## Service Bulletin

## Announcement of System Version 8.0

DX-D 100 / DX-D 100 Wireless

Agfa HealthCare Company Confidential Type 5410/050 / 5411/050/300/400

Figure 1

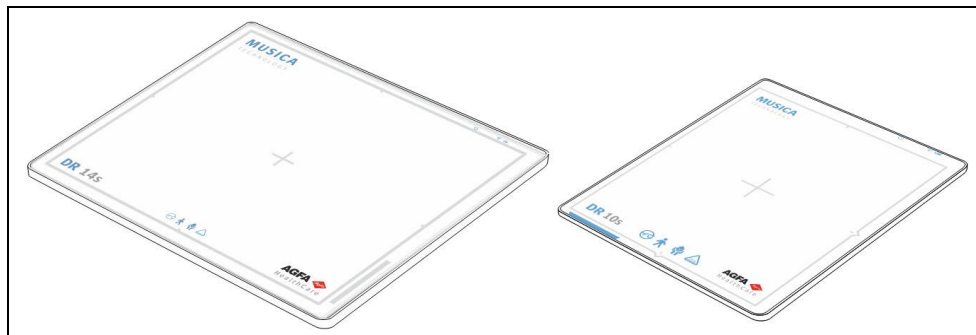
With DX-D 100 Wireless system version 8.0 the new DR 14s and DR 10s wireless detectors with **Trixiell Detector Software TRI 2.0** are introduced.

- The large DR 14s detector is available as Csl and GOS version.
- The small DR 10s detector is only available as Csl version.
- Detector sharing is supported (one detector used on different NX) for DR 10s/14s detectors.
- The new Subtype 5411/400 for DX-D 100 Wireless was created.

Figure 3

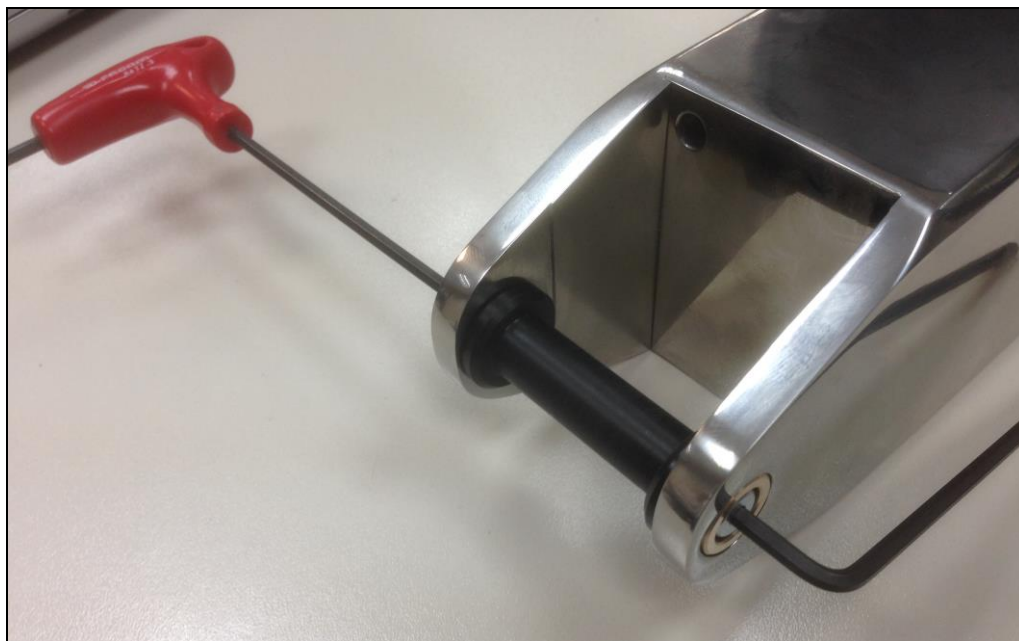
*Symptom* Telescopic arm locked in park position due to loosen screws.

*Cause* The loosen screws of the pin locks the arm in the park position.

*Solution* Attachment of the pin with 2 Allen wrench's instead of only one.
